HISTORIC AND DESIGN REVIEW COMMISSION

HDRC CASE NO: 2017-561
ADDRESS: 431 ADAMS ST
LEGAL DESCRIPTION: NCB 2880 BLK 5 LOT 9
ZONING: RM-4, H
CITY COUNCIL DIST.: 1
DISTRICT: King William Historic District
APPLICANT: Hoda Cummings
OWNER: Hoda Cummings
TYPE OF WORK: Construction of a rear accessory structure
APPLICATION RECEIVED: October 24, 2017
60-DAY REVIEW: December 23, 2017
REQUEST:

The applicant is requesting a Certificate of Appropriateness for approval to construct a rear accessory structure at 431 Adams Street.

ELEVATIONS
SCALE: 1/4" = 1'-0"

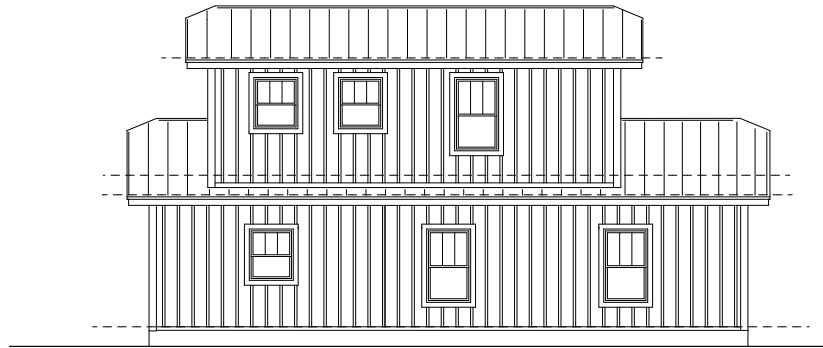
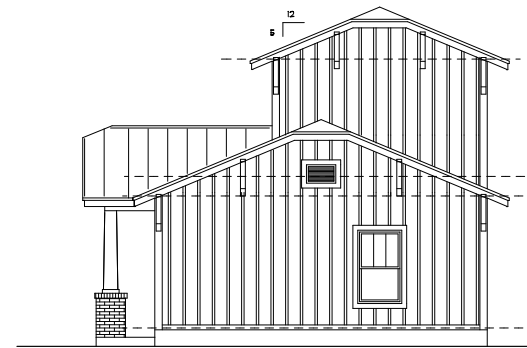
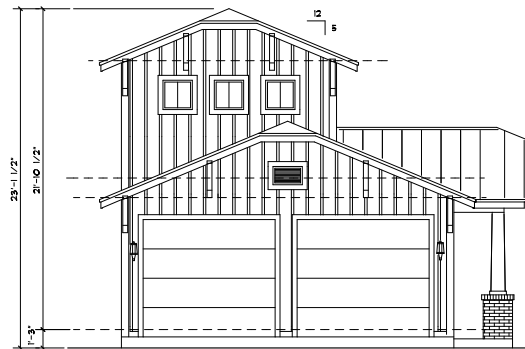
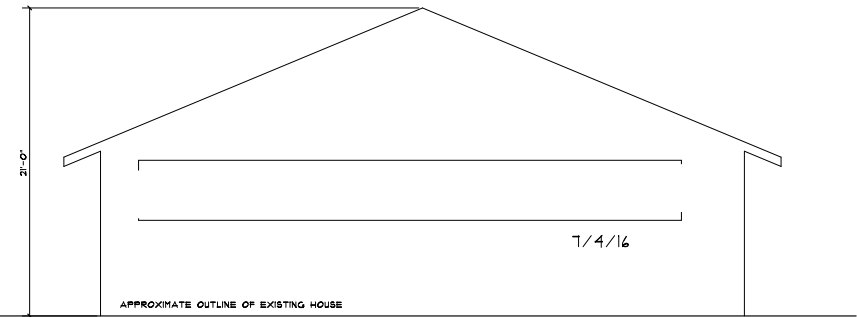
- b. **MASSING & FORM** – According to the Guidelines for New Construction 5.A.i. new accessory structure should be designed to be visually subordinate to the primary historic structure in terms of their height, massing and form. The primary historic structure at 431 Adams features a single story with a foundation height of approximately two feet and an overall height of 21' - 0". The applicant has proposed to construct an accessory structure to include

two levels and an overall height of 23' – 1 ½". In terms of height, while the proposed structure is slightly taller than the primary historic structure, staff finds its height is generally appropriate in context with other accessory structures along both Adams and Barbe.

- e. **MATERIALS** – The applicant has proposed materials that include Hardi board and batten siding, wood windows and a standing seam metal roof. The applicant has provided information noting that the proposed board and batten siding will match the board and batten siding found on accessory structures that are addressed to Adams, but front Wickes where the primary structure is of craftsman influence. Staff finds the applicant's proposed siding profile appropriate; however, board and batten siding should feature boards that are twelve (12) inches wide with battens that are 1 – ½" wide. The standing seam metal roof feature panels that are 18 to 21 inches wide, seams are 1 to 2 inches in height, a crimped ridge seam and a standard galvalume finish. The applicant has noted that the proposed wood windows will be inset two inches within the walls.

- f. **ARCHITECTURAL DETAILS** – Since the time of conceptual approval, the applicant has proposed additional windows fenestration to prevent long expanses of blank walls. The applicant has proposed window proportions that are complimentary of those found on the craftsman structure. Additionally, the applicant has proposed elements such as eave brackets and craftsman style porch columns.

- g. **GARAGE DOORS** – Regarding the installation of garage doors, the applicant has proposed to install a steel paneled garage door with top row window lites. Staff finds that a wood door should be installed to match those found historically in the district.

- i. That the applicant install board and batten siding feature boards that are twelve (12) inches wide with battens that are 1 – ½" wide, that the standing seam metal roof feature panels that are 18 to 21 inches wide, seams are 1 to 2 inches in height, a crimped ridge seam and a standard galvalume finish.
- ii. That window trim feature traditional dimensions and an architecturally appropriate sill detail.
- iii. That a wood garage door be installed to match those found historically in the district.
- iv. **ARCHAEOLOGY**- Archaeological investigations may be required. The archaeological scope of work should be submitted to the OHP archaeologists for review and approval prior to beginning the archaeological investigation. The development project shall comply with all federal, state, and local laws, rules, and regulations regarding archaeology.
